# CITY PLANNING COMMISSION

- APPLICATION:
- A. Certification of the Environmental Impact Report (SCH No. 87062506)
  - B. Major Project Special Permit to develop a 19 story, 602,000+ square foot office building with ground floor retail and six levels of parking (576 parking spaces) on 0.88+ acres in the Central Business District- Special Planning District (C-3) zone.
  - C. Special Permit to allow attendant/tandem parking in the C-3 Zone.
  - D. Variance to exceed the maximum 30% compact car parking spaces by 1% (31%)
  - E. Lot Line Adjustment to relocate the common property lien of two lots and merge six lots.

LOCATION: 1325 J Street

APPLC. NO. P88-161 MEETING DATE September 15, 1988 ITEM NO. 2

ELEVATIONS

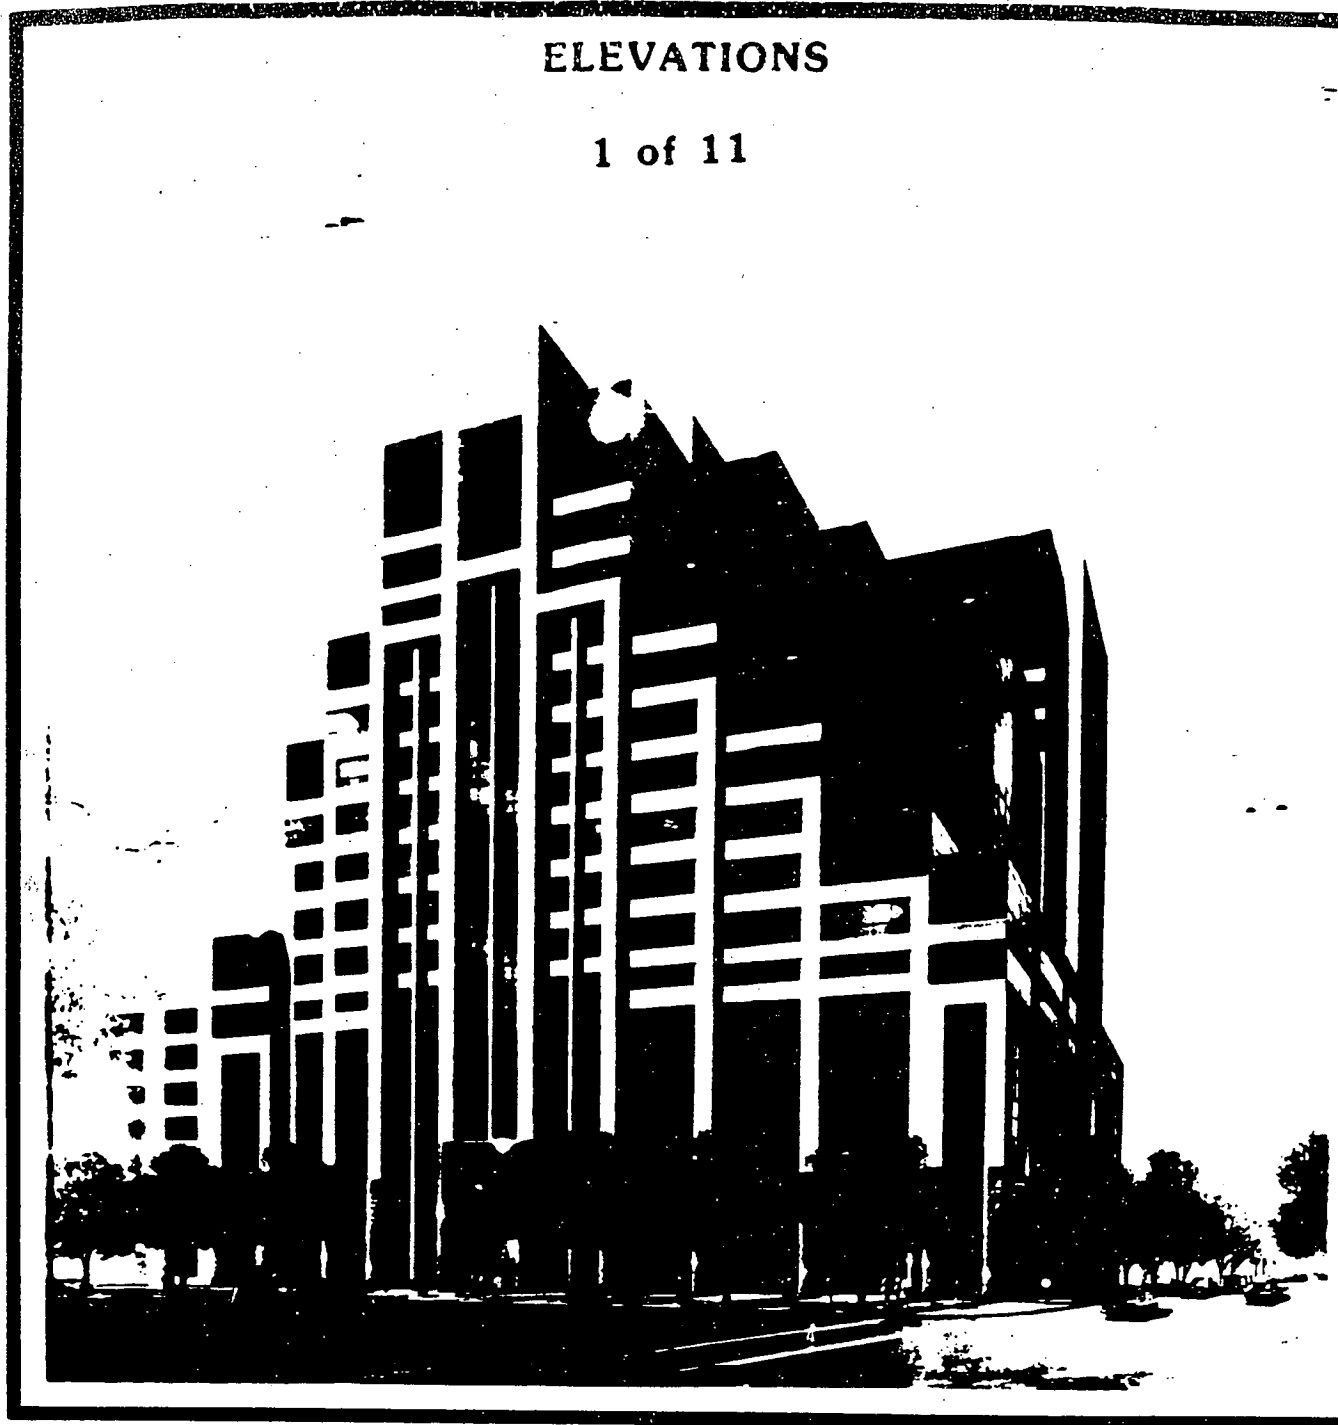
The applicant proposes to construct the building with rust red granite (ground through third floor levels), tan pre-cast concrete panels and bronze reflective glass. Clear glass windows are proposed along the ground floor retail space. The project architect, at Planning staff's suggestion increased the height of the base of the building from 60 feet to 107+ feet in order to obscure the east facade (fire wall) of the adjacent seven story office building to the west. The proposed structure complies with the intent of the maximum lower (220 feet) and upper (200 feet) tower diagonals in that the floor plates on the average meet the building diagonal requirements. This is achieved by some portions of the floor plate being less than maximum on some of the floors and other portions exceeding the maximum. Architectural design and landscape features which have been incorporated into the project include: square columns at street level which are similar in shape to the plasters on the public market, a 22+ wide recessed pedestrian colonade along the J Street building base, landscaping adjacent to the recessed pedestrian ways and decorative treatment of the public sidewalks. Glassed in elevators and stairwells adjacent to the J Street facade are designed to orient the building to the streetscape and encourage use of the buildings parking facilities by Convention Center patrons after normal business hours and on the weekends. The project will be scheduled for the review of the City Design Review/Preservation Board after action has been taken by the Planning Commission. Planning staff is generally supportive of the overall design of the project but is concerned that the structure appears to be too massive, especially along the J Street facade. The building is also not inviting to the pedestrian. The applicant needs to rework, at a minimum the front elevation to provide more visual relief. Possible design modifications include:

1. Reducing the size of some of the floorplates and increasing the building height.
2. Provide more of a visual transition and/or setback between the office portion and garage portion of the structure, particularly along the J Street frontage.
3. Increase the setback of each vertical column bay on each side of the main building entrance.
4. The present design of the colonade is not conducive to pedestrian movement nor attractive to retail tenants. It is suggested that the project architect study the ground floor design to achieve more continuous pedestrian movement. Possible design modifications include: relocating or removing the various stairwells located along the J Street facade; elimination of the wall between the elevator lobby and the colonade; and redesigning the lobby entry.

10. The applicant shall address the following design modifications to the building at the City Design Review/Preservation Board hearing:
  1. Reducing the size of some of the floor plates and increasing the building height.

2. Provide more of a visual transition and/or setback between the office portion and garage portion of the structure, particularly along the J Street frontage.

3. Increase the setback of each vertical column bay on each side of the main building entrance.
  4. The present design of the colonade is not conducive to pedestrian movement nor attractive to retail tenants. It is suggested that the project architect study the ground floor design to achieve a study more continuous pedestrian movement. Possible design modifications include: relocating or removing the various stairwells located along the J Street facade elimination of the wall between the elevator lobby and the colonade and redesigning the lobby entry.
